**CITY OF DOVER PLANNING COMMISSION
AGENDA**

**Monday, October 16, 2017– 7:00 P.M.
City Hall, City Council Chambers
15 Loockerman Plaza, Dover, Delaware**

**CITY OF DOVER PLANNING COMMISSION
SEPTEMBER 18, 2017**

PHASING PLAN -
FULL BUILDOUT

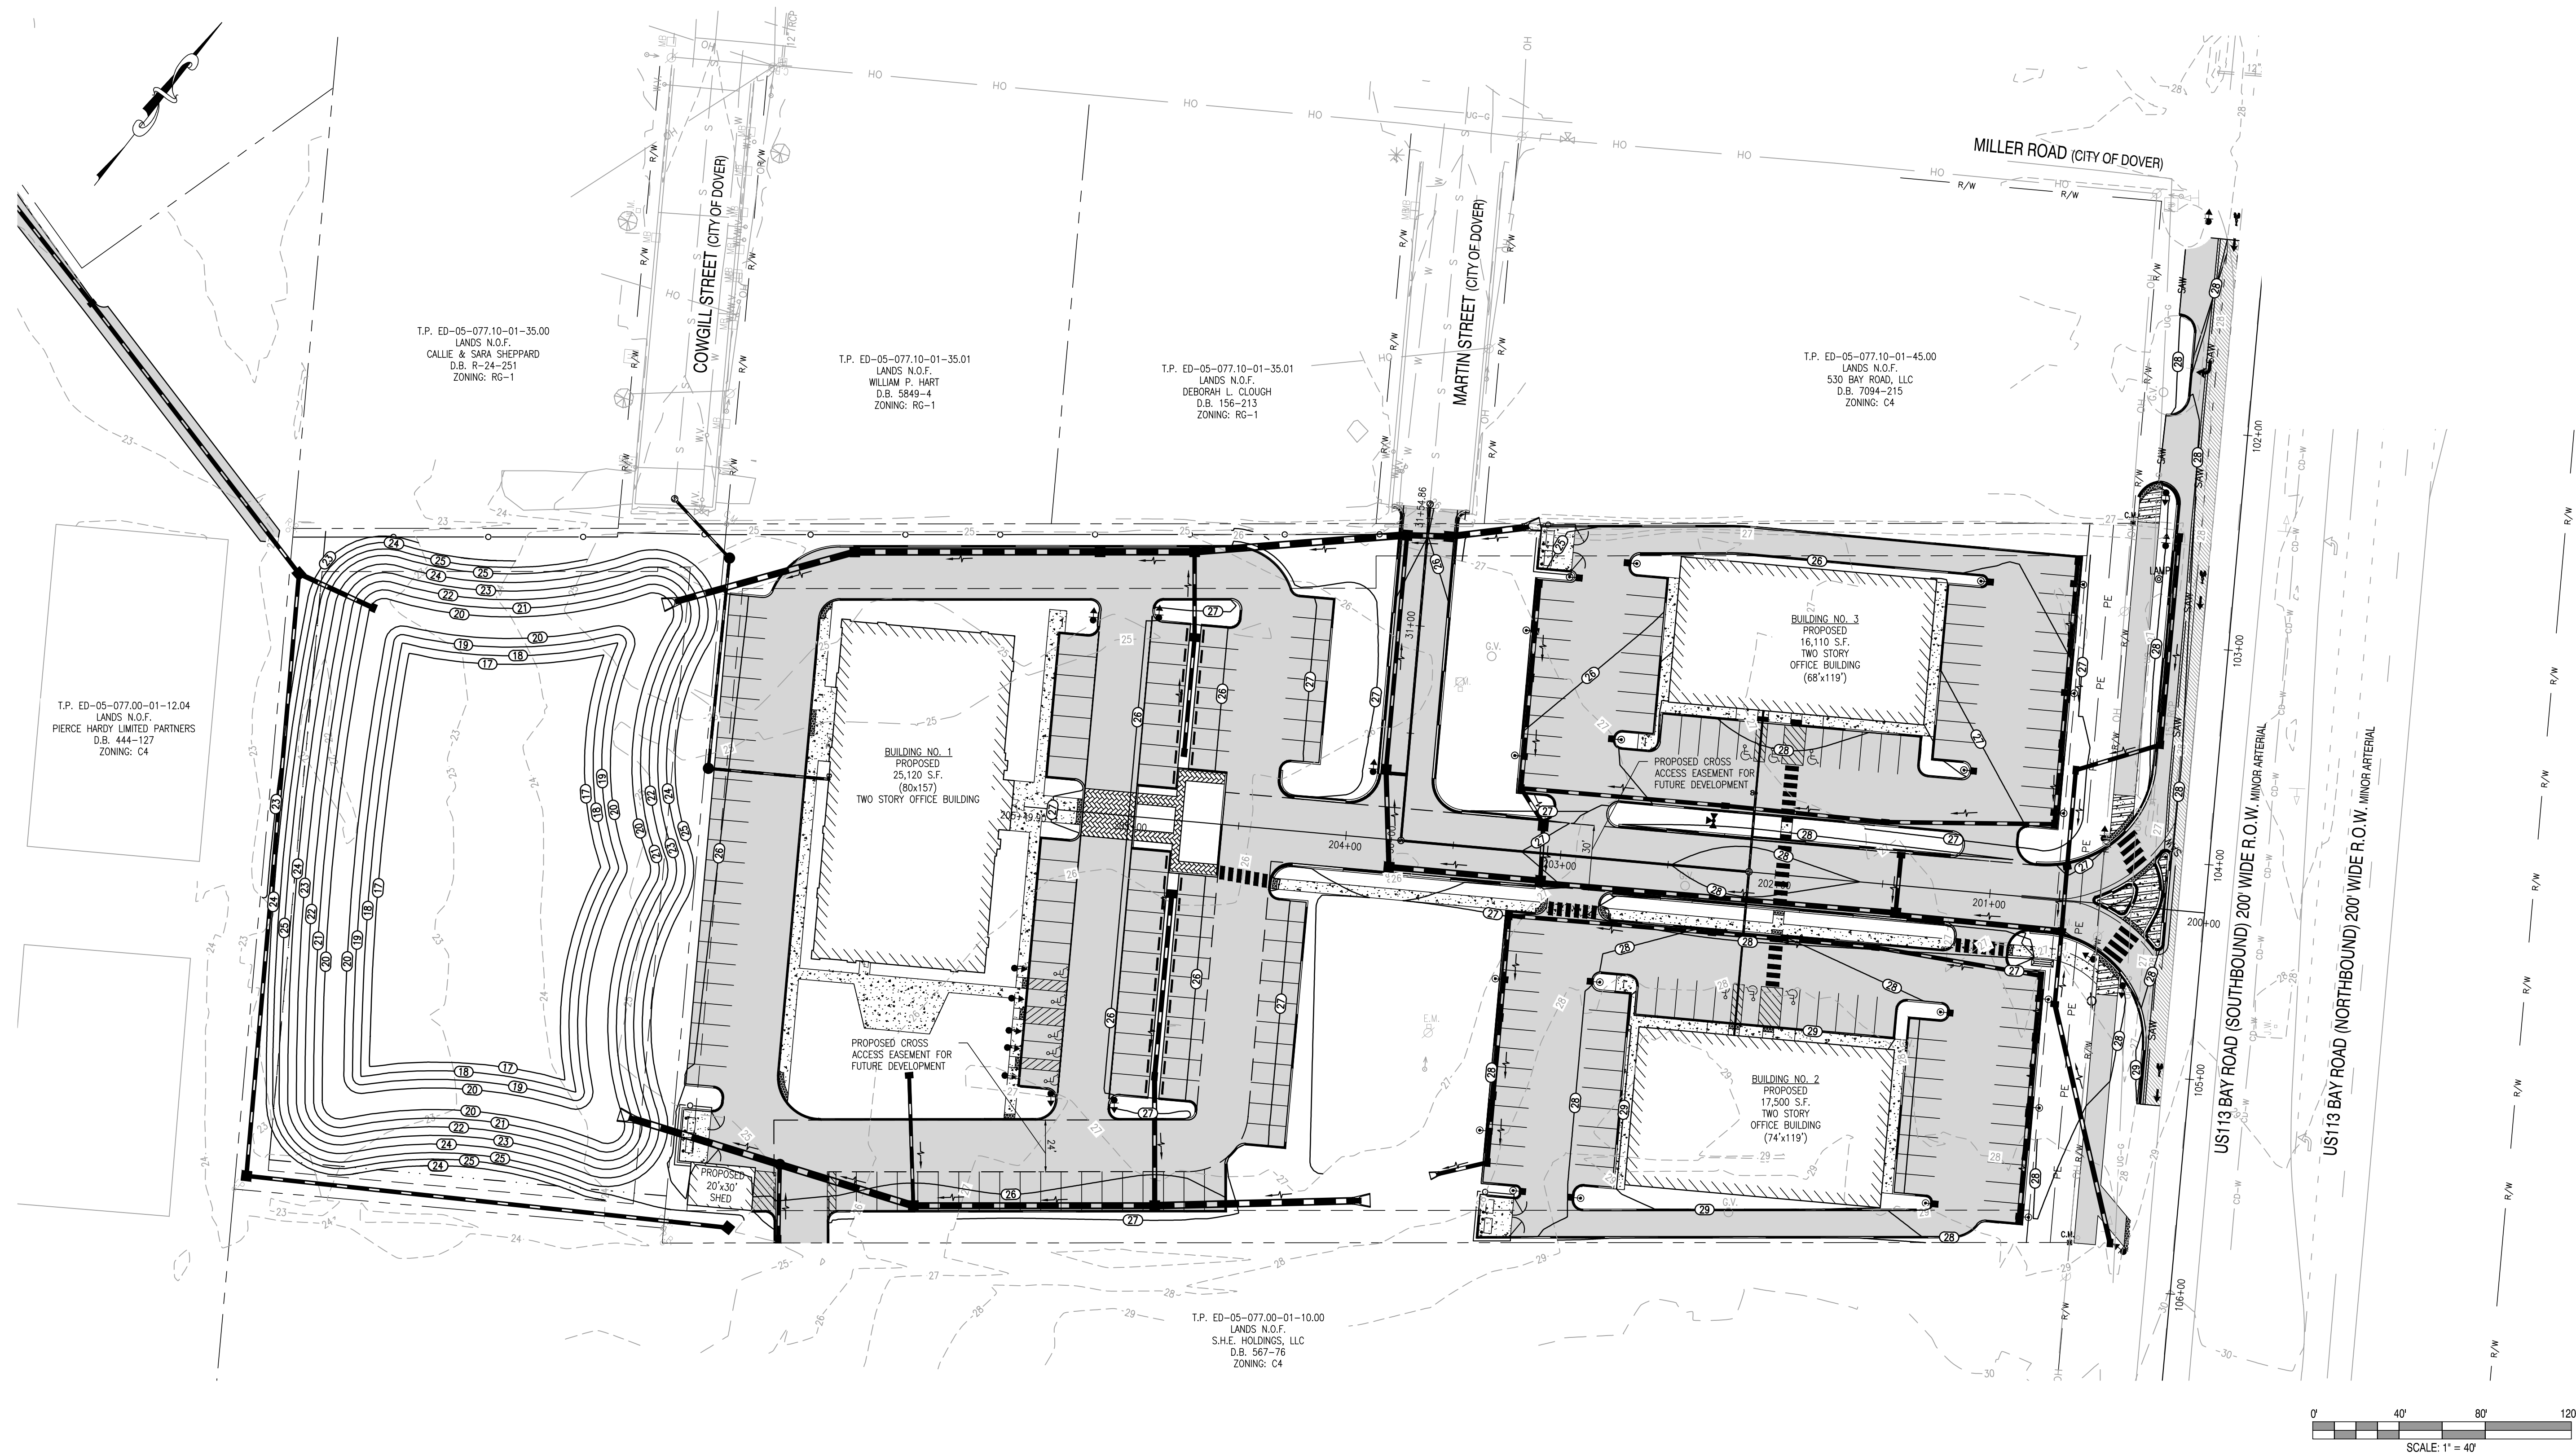
1. **Building 4/Phase 4 has been eliminated.** The initial Master Plan presented to the Planning Commission included a 15,000 SF building at the rear of the project, on parcel T.P. ED-05-077.00-01-11.00. This building was designated as Phase 4 of construction. During the design process soils on the site were found to be poorly draining and insufficient for infiltration. The revised stormwater design requires construction of a wet stormwater pond at the rear of the site, where Building 4 was formerly located.
2. **A cross-access connection with the parcel to the south has been included.** At the requirement of DelDOT, a cross-access connection has been placed between the parking lot of Building 1 and the parcel to the south that is currently in design for future development.

Other minor design changes, such as drainage revisions and parking lot adjustments have also occurred, but do not impact the overall design of the site.
